# Access Compliance Report

## Public Rights-of-Way

### (Curb Ramps)

Intersection ID: 54217	Main Street: GOLF_LINKS_DR	Cross Street: MIDWAY_PARK_DR	Location: SE
ADA ID: 0DA1AC644DA2	Ramp Type: Perp	Initial Pass/Fail: Fail	Overall Compliance: No
		Severity Score: 1.25

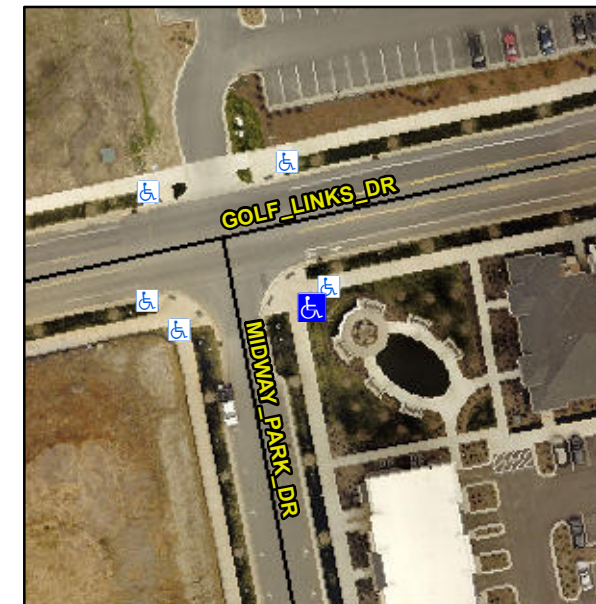
**Not Found, R304.5.3**

Compliance	Description	Data	Compliance	Description	Data
N/A	Ramp Length (in)	142.0	Yes	Ramp Slope (%)	8.1
Yes	Ramp Width (in)	59.0	No	Ramp XSlope (%)	3.6
N/A	Flare Type LT	N/A	N/A	Flare Type RT	N/A
N/A	Flare Slope LT (%)	N/A	N/A	Flare Slope RT (%)	N/A
N/A	Flare Traversable LT?	N/A	N/A	Flare Traversable RT?	N/A
N/A	Landing Length (in)	N/A	N/A	DWS Provided?	N/A
N/A	Landing Width (in)	N/A	N/A	DWS Contrast?	N/A
N/A	Landing Slope (%)	N/A	N/A	DWS Length (in)	N/A
N/A	Landing X Slope (%)	N/A	N/A	DWS Full Width?	N/A
N/A	Landing Curb? (Y/N)	N/A	N/A	DWS Offset (in)	N/A
N/A	Shared Landing?	N/A			
N/A	Gutter Ponding?	N/A	N/A	Gutter Slope (%)	N/A
N/A	Gutter Lip Ht (in)	N/A	N/A	Gutter X Slope (%)	N/A
N/A	Painted X Walk1?	No	N/A	Painted X Walk2?	N/A
	X Walk 1 Direction	To W		X Walk 2 Direction	N/A
N/A	X Walk 1 Width (in)	N/A	N/A	X Walk 2 Width (in)	N/A
	X Walk 1 Slope (%)	1.1		X Walk 2 Slope (%)	N/A
	X Walk 1 X Slope (%)	3.4		X Walk 2 X Slope (%)	N/A

**Remove & Replace Entire Ramp.**
